Rosamond High Early College Campus Cafeteria Building
SOUTHERN KERN UNIFIED SCHOOL DISTRICT
F&M Project No. 2990
Bid Clarification No.3; Page 1 of 2

BID CLARIFICATION NO. 4

July 18, 2023

Job No.

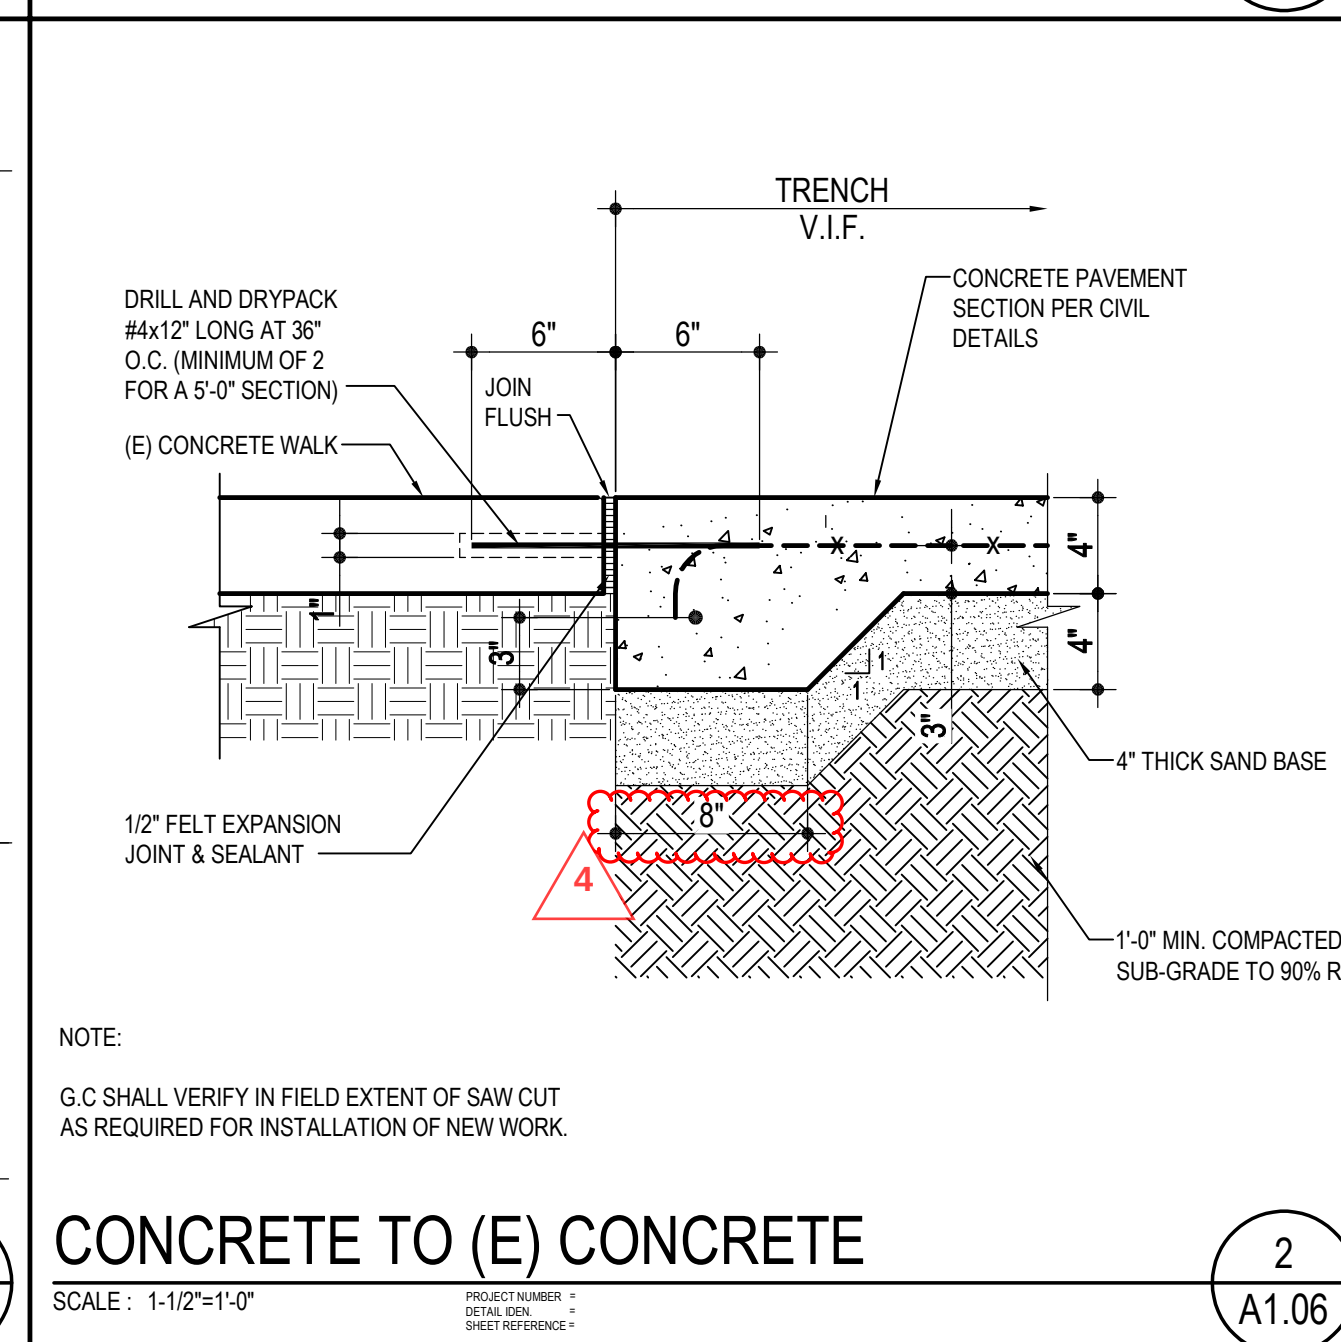
1. A1.04 – Overall Site Plan, "Bid Clarification No.4", with revision clouds as attached hereto.
2. A1.06 – Site Details, "Bid Clarification No.4", with revision clouds as attached hereto.

FLOOR PLAN

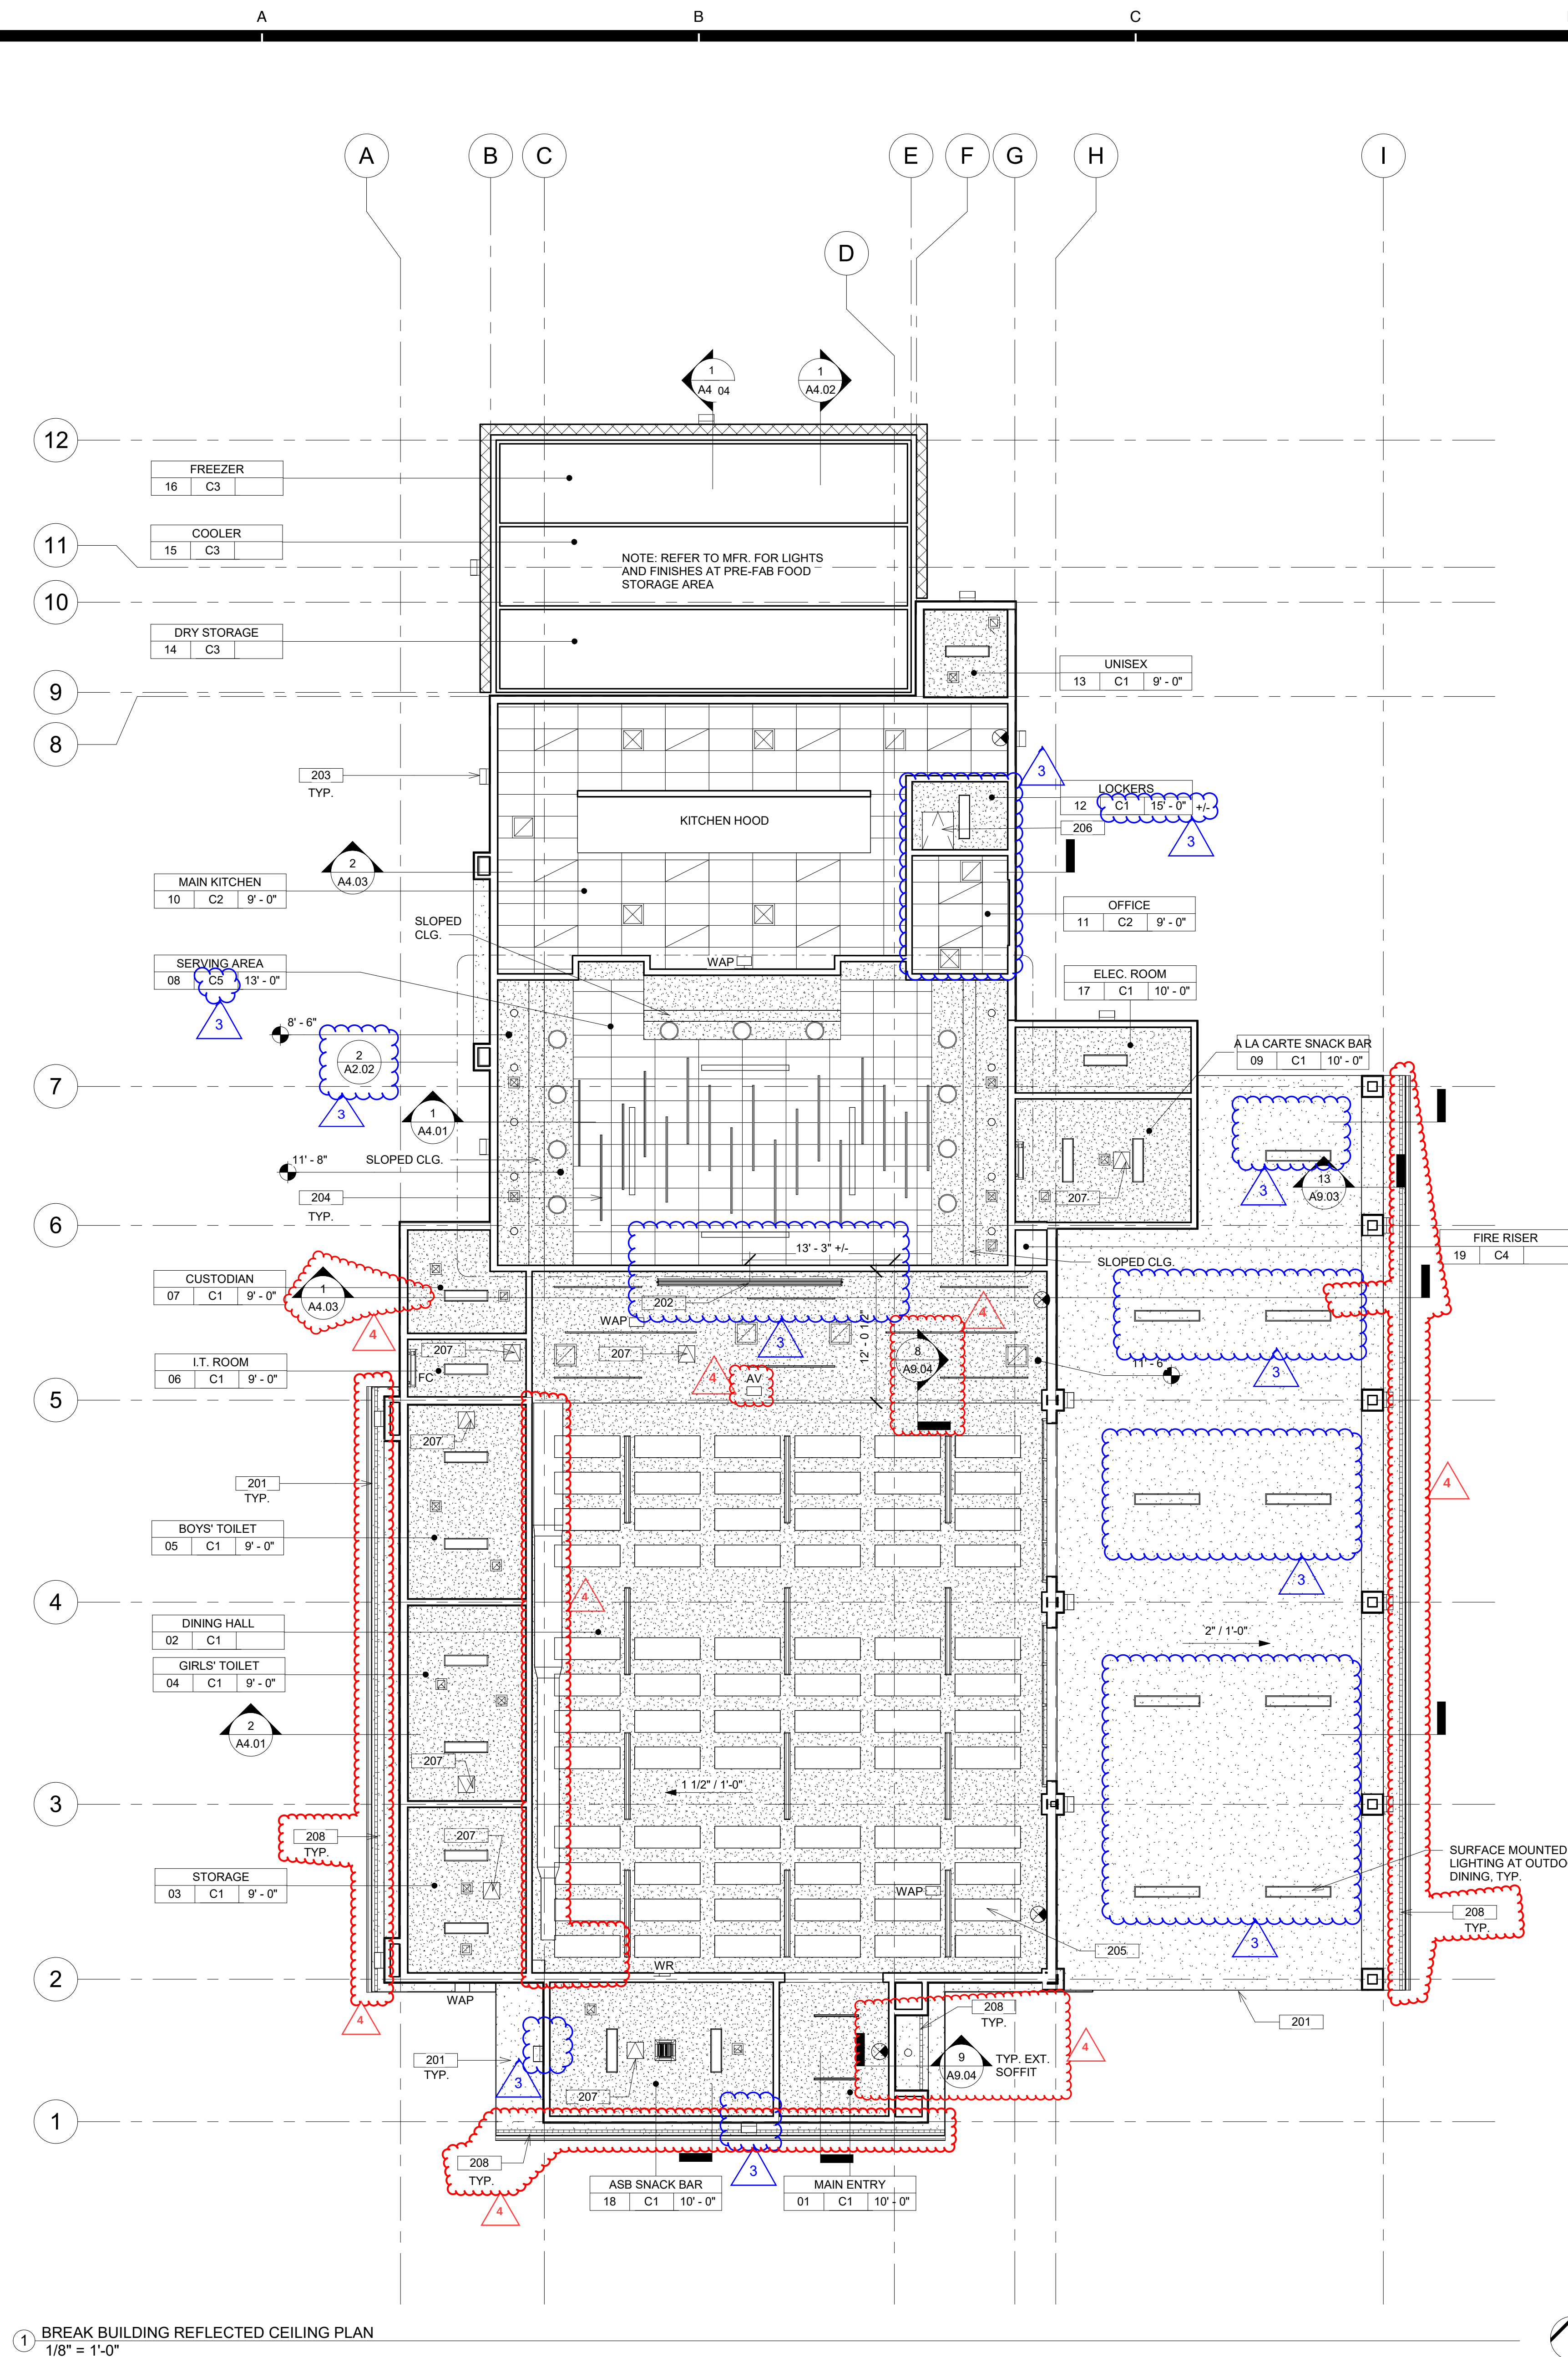
3. A1.07 – Site Details, "Bid Clarification No.4", with revision clouds as attached hereto.
4. A2.01 – Floor Plan, "Bid Clarification No. 4", with revision clouds as attached hereto.

REFLECTED CEILING
PLAN

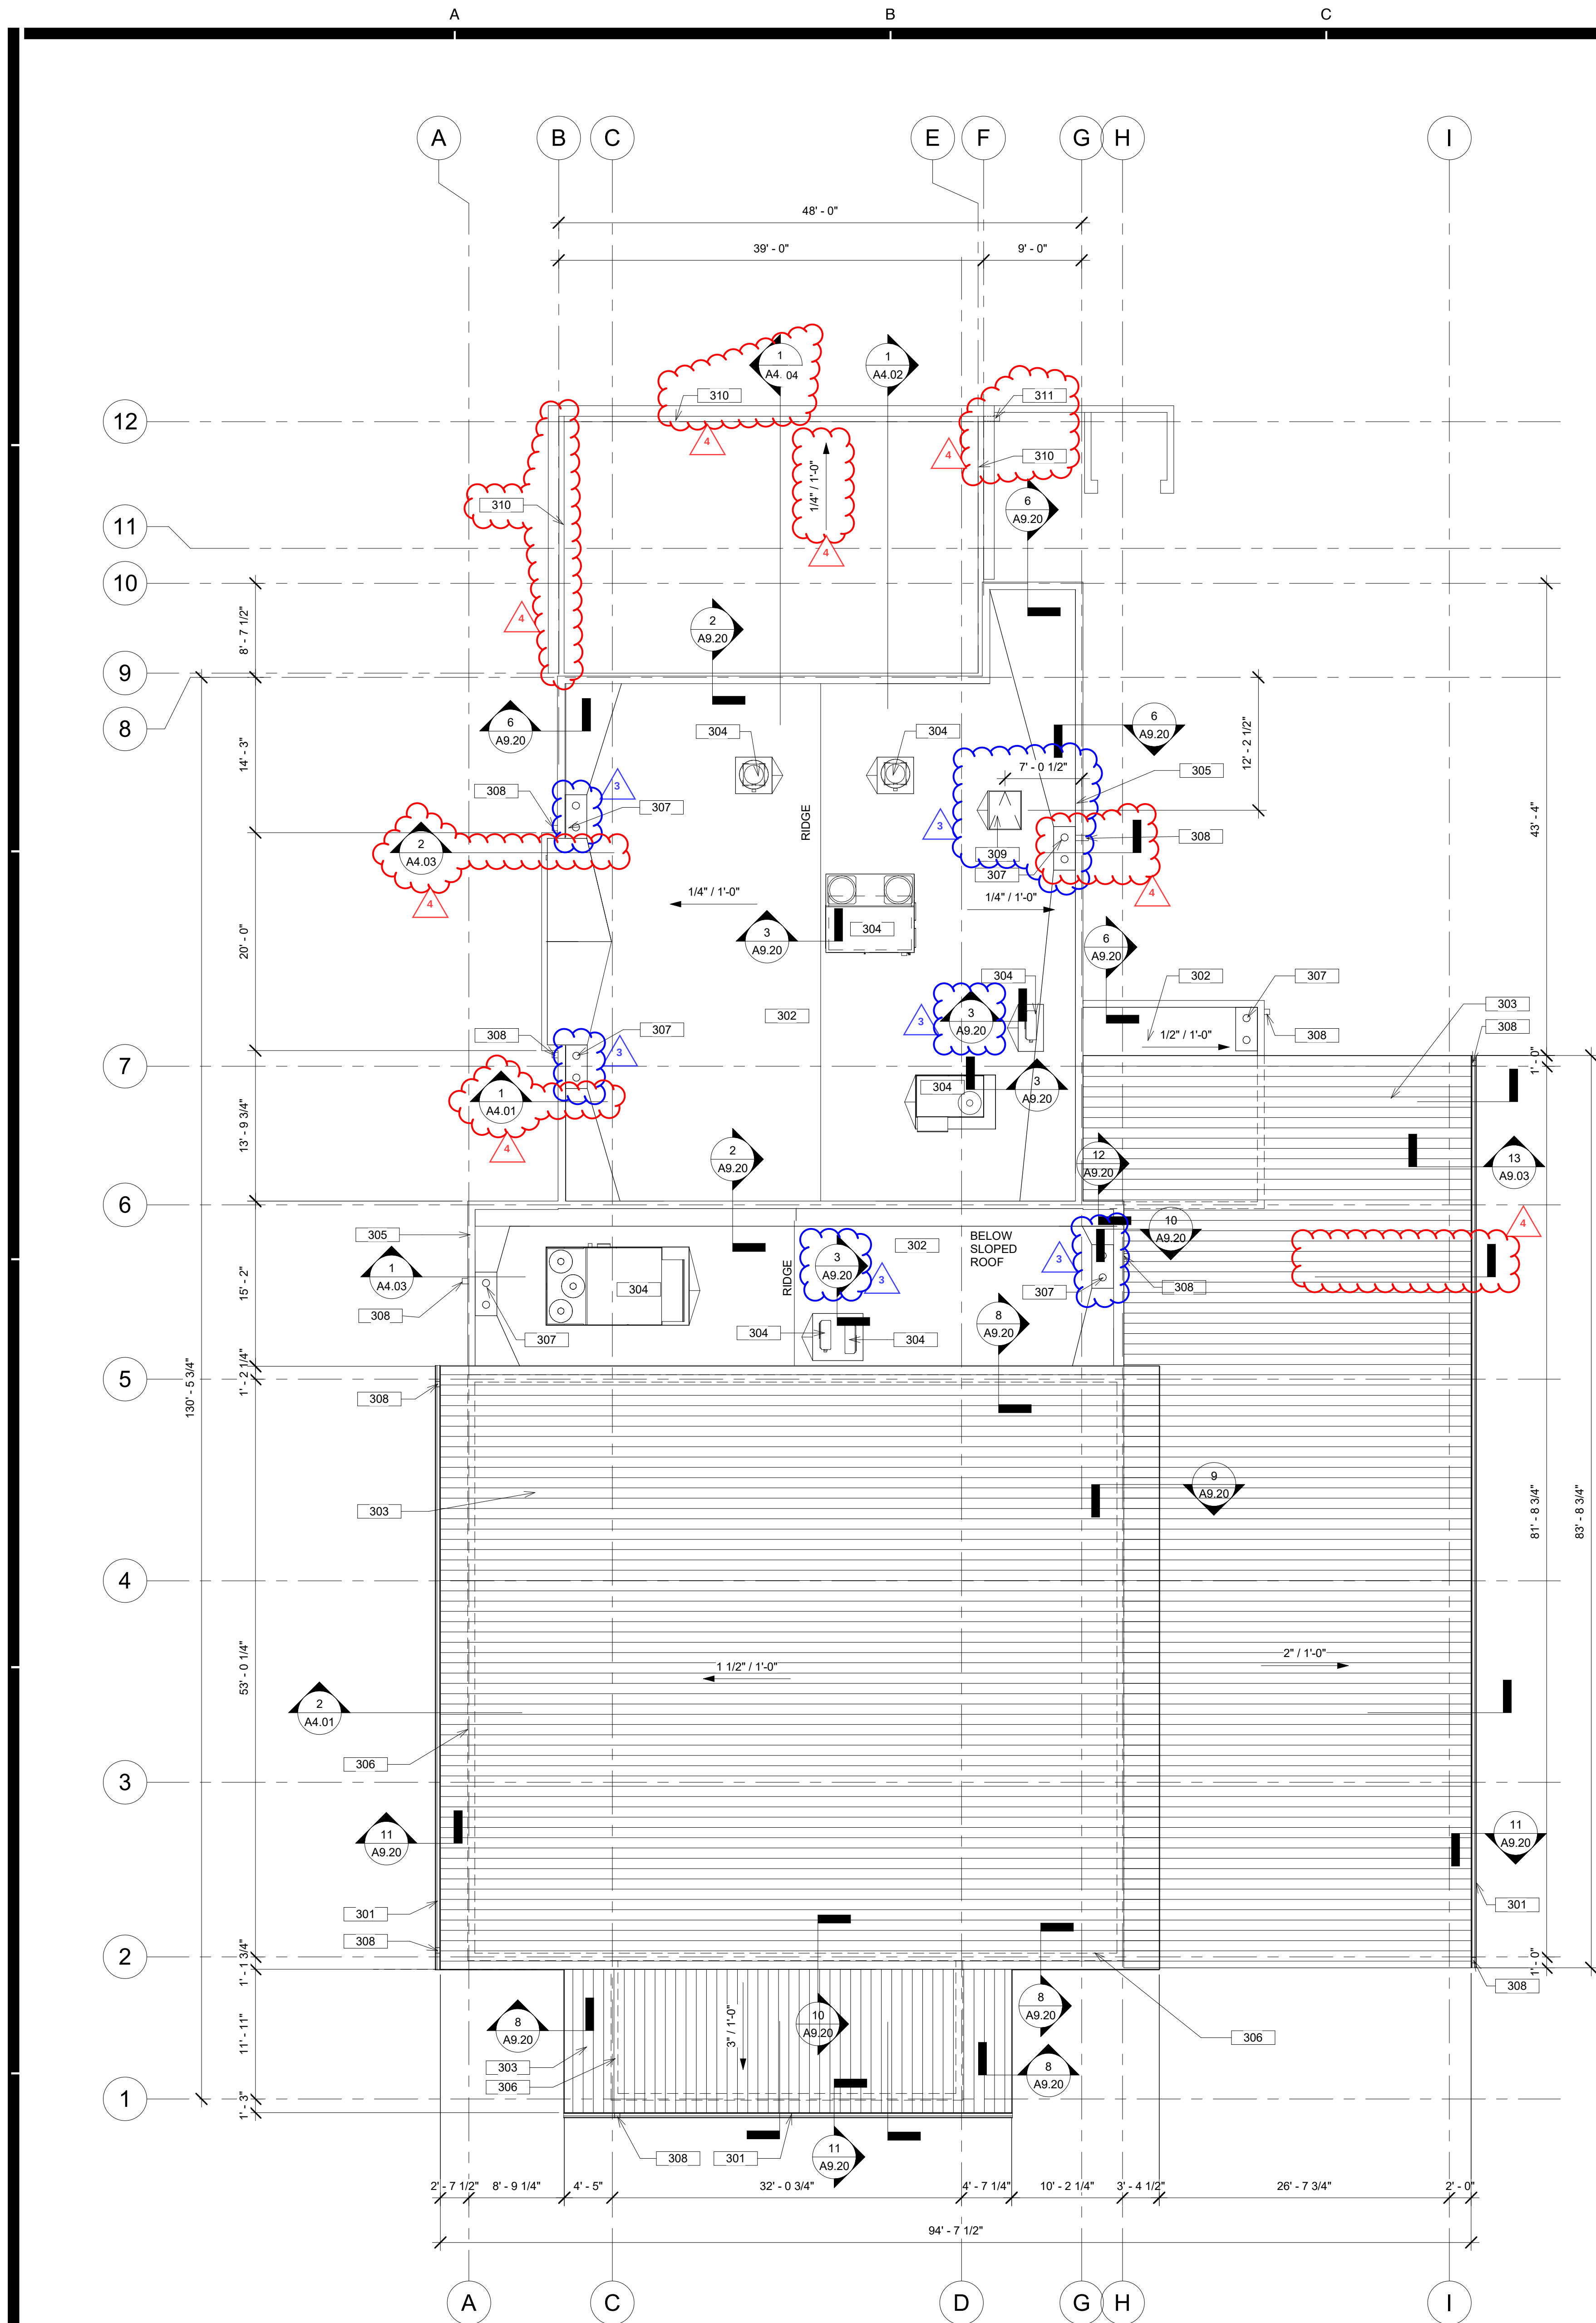
5. A2.02 – Reflected Ceiling Plan, "Bid Clarification No. 4", with revision clouds as attached hereto.
6. A2.03 – Roof Plan, "Bid Clarification No. 4", with revision clouds as attached hereto.
